ONS2006001  
November 30, 2006

Subject: Duke Power Company LLC d/b/a Duke  
Energy Carolinas, LLC (Duke)  
Oconee Nuclear Station, Units 1, 2, and 3  
Docket Numbers 50-269, 50-270, and 50-287  
Tornado/HELB Mitigation Strategies and Regulatory Commitments

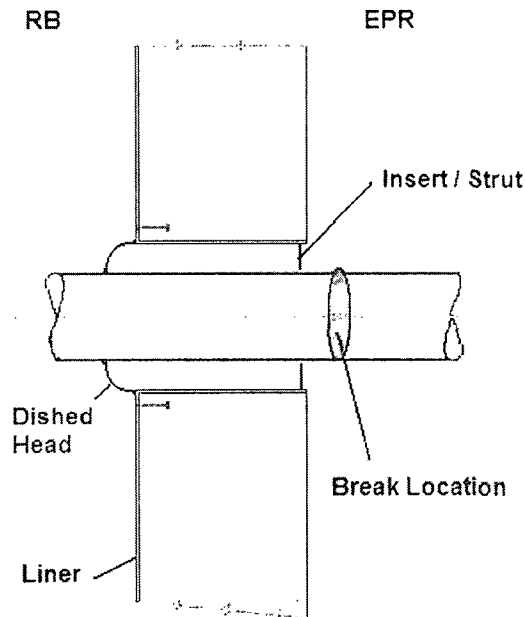
*A description should be provided of the methods or analyses performed to demonstrate that there will be no adverse effects on the primary and/or secondary containment structures due to a pipe rupture outside these structures.*

In general, the Reactor Building (RB) penetrations represent terminal ends in the piping analyses. Two types of piping penetration designs were installed at ONS; those for the small bore piping penetrating the primary containment, and those for the MS and MFW piping penetrating the primary containment. Each RB penetration is designed to withstand the forces and moments that could be applied to the terminal end should a break occur in the piping line outboard of the terminal end. This design protects the primary containment from breaks that could occur outboard of the terminal end.

The small bore penetration design is provided below. The design consists of a hollowed out dished head and either struts or penetration inserts. The dished head is located inside the RB and is designed to absorb the axial and lateral forces and torsional moment should a break occur in the piping outboard of the terminal end. The inside circumference of the dished head is welded directly to the outside surface of the process pipe. The outside diameter of the dished head is welded directly to a housing that is in turn welded to the primary containment liner. The penetration inserts or struts were located outside of the RB in the penetration rooms. The inserts/struts are designed to absorb lateral forces from the break.

### MFW Penetration

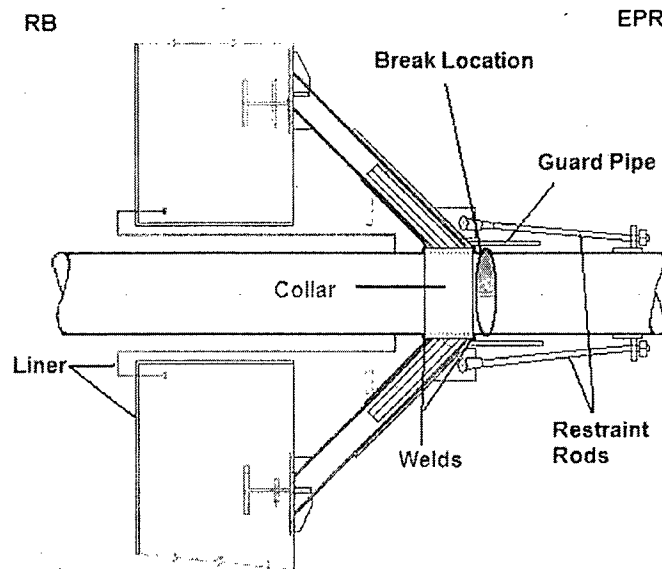
The MDS report described breaks postulated to occur at the MFW containment penetrations. These breaks were located outboard (penetration room side) of the terminal end. Containment integrity is protected from breaks postulated to occur at these locations.

The design of the MS and MFW RB penetrations differ from the small bore RB penetrations. For these lines, structural anchors have been installed adjacent to the RB penetrations. The two MFW structural anchors are located in the EPR. These anchors are designed to absorb the large forces and moments that could occur in the aftermath of a postulated MFW break occurring outboard of the structural anchor. The MFW anchors consist of a collar wrapped around the outside diameter of the piping. The collar is connected at both ends to the piping via two circumferential fillet welds. The collar is in turn welded to a series of structural wide flange members that span back to the RB wall. The wide flange members are then welded to embedded structural tees located in the RB wall. A simplified sketch of the MFW penetration follows:

### MS Penetration

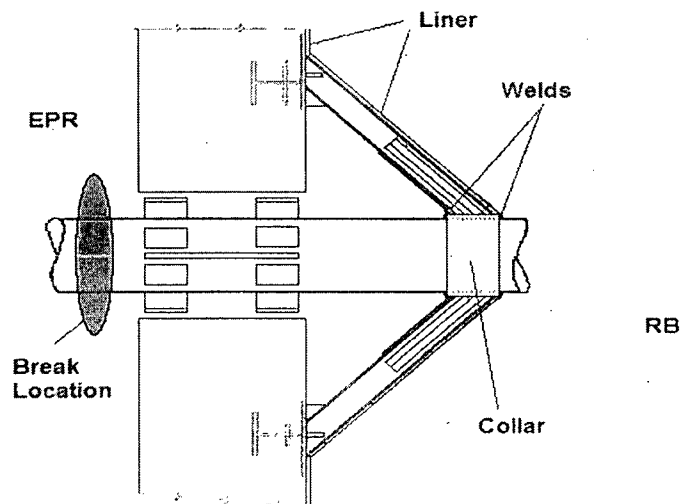
The MDS report described breaks postulated to occur at the MS containment penetrations. These breaks were located outboard (penetration room side) of the terminal end. Containment integrity is protected from breaks postulated to occur at these locations.

The MS RB penetration is similar to the MFW design. While the MFW structural anchor is located inside the EPR, the structural anchor adjacent to the MS penetration is located inside of containment, as shown below.

#### MFW Break Location in EPR

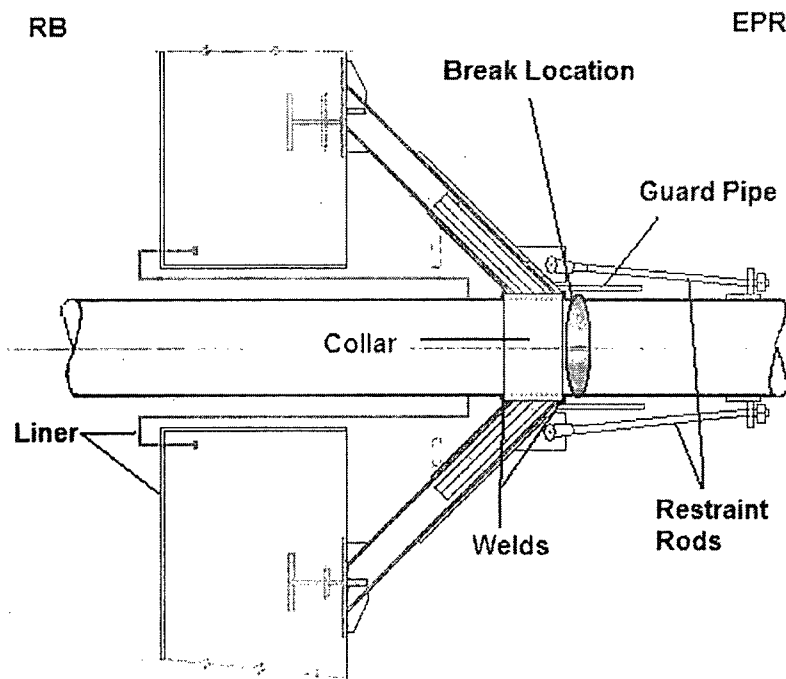
In the response to Question 7 regarding the circumstances and action supporting the acceptability of ONS's design, under (3), the following is noted: "Duke will increase the in-service inspection to include the metal surface inspection for the postulated break area every 5 years to detect any surface defects." In the MDS HELB report, the postulated break area is not at the terminal end (structural anchor) which is located inside the RB, but rather is located away from the anchor point inside the EPR (See MS break location in EPR sketch below). Note that the break location is inside the EPR away from the structural anchor.

inspections will be attempted during the upcoming Unit 2 outage slated for the Spring 2007. ONS will apprise the NRC of the status of these inspections following those outages. See the sketch below.

ONS agrees that these inspections are important in ascertaining the overall fitness of the MFW lines in the EPR, but the inability to inspect certain welds does not mean that a break should be postulated at those locations. The location of the MFW terminal end break was given in the HELB report and detailed here in the MFW sketch shown above. A rupture restraint was designed and implemented in 1974 to mitigate the break located just upstream of the outboard (EPR) terminal end weld. The SER for Units 2 & 3 (dated 7/6/73) approved the original HELB report, and noted the following: "The staff has evaluated the assessment performed by the applicant and has concluded that the applicant has analyzed the facilities in a manner consistent with the intent of the criteria and guidelines provided by the staff. The staff agrees with the applicant's selection of pipe failure locations and concludes that all required accident situations have been addressed appropriately by the applicant." ONS concludes that the original MFW terminal end break location is sufficient for meeting the HELB requirements.
